Number 98

**SUBJECT:** Battery Insulator

**TO:** Owners of Piper Model PA-12 Airplanes  
Serial Nos. 12-1 to 12-796 inclusive,  
12-815, 12-817, to 12-822 inclusive,  
12-825 to 12-831 inclusive, 12-833,  
12-835 to 12-848 inclusive, 12-863 to  
12-893 inclusive, 12-895 to 12-901  
inclusive.

BATTERY SPACER INSTALLATION

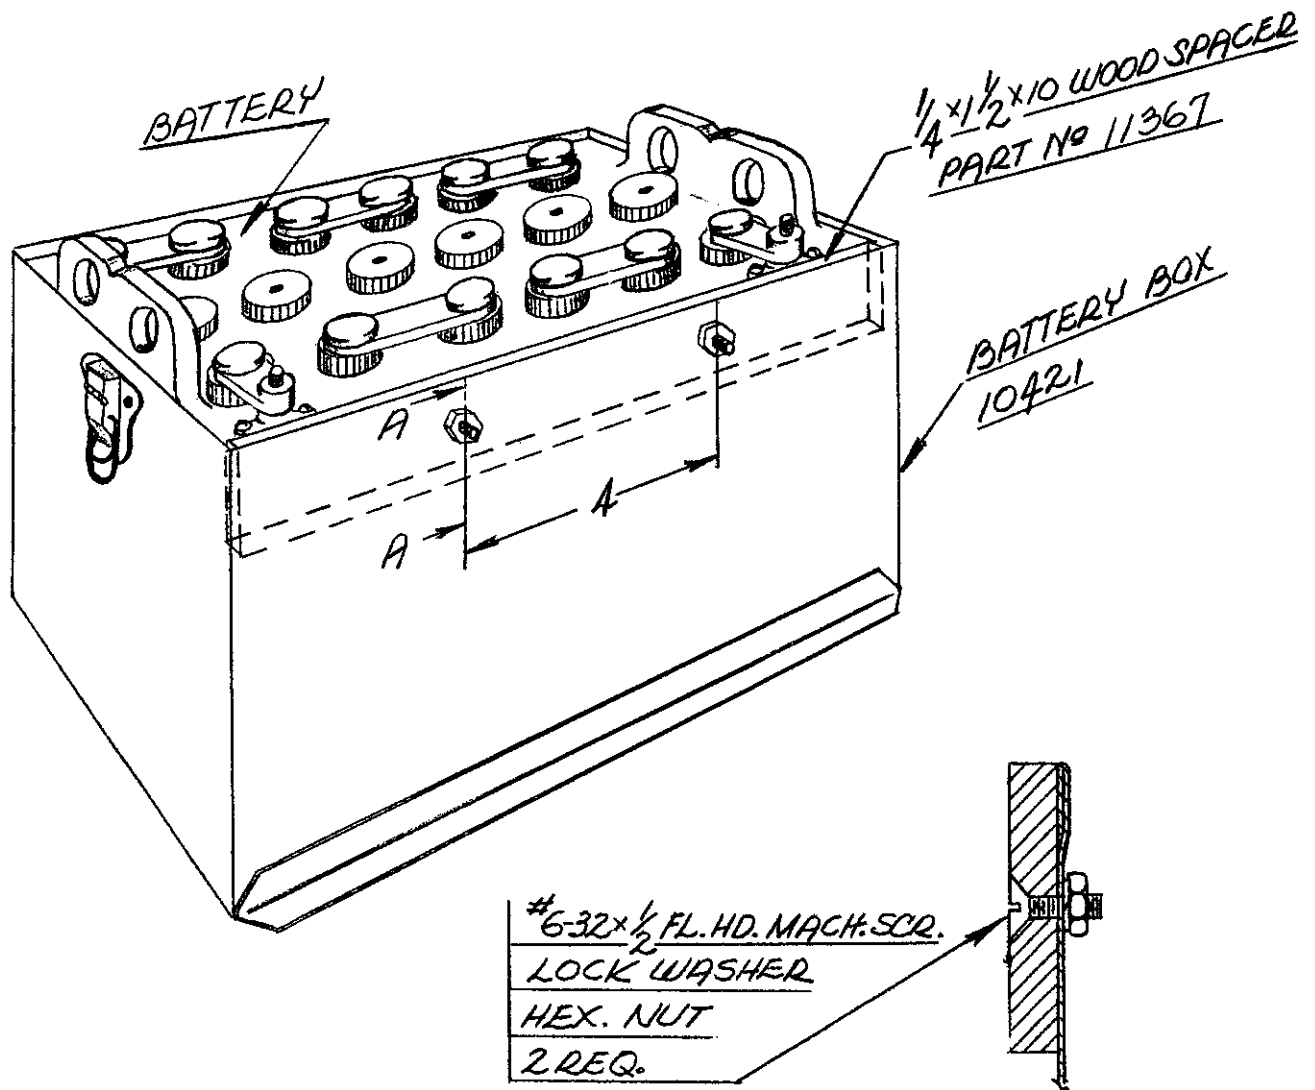
It has been discovered that there is a possibility of a short circuit occurring between the battery terminal bases and the battery box on the above airplanes.

To eliminate this possibility, it is recommended that a strip of wood be fastened to the upper inside edge of the battery box (on the terminal side), as shown on the sketch on the opposite side of this bulletin.

If the Reading R24L Battery has been replaced with an S24 Battery, and the proper spacer channels, Part No. 10926 and 10927, installed, it will not be necessary to add the wood strip.

An appropriate entry should be made in the aircraft log book upon the completion of this change.
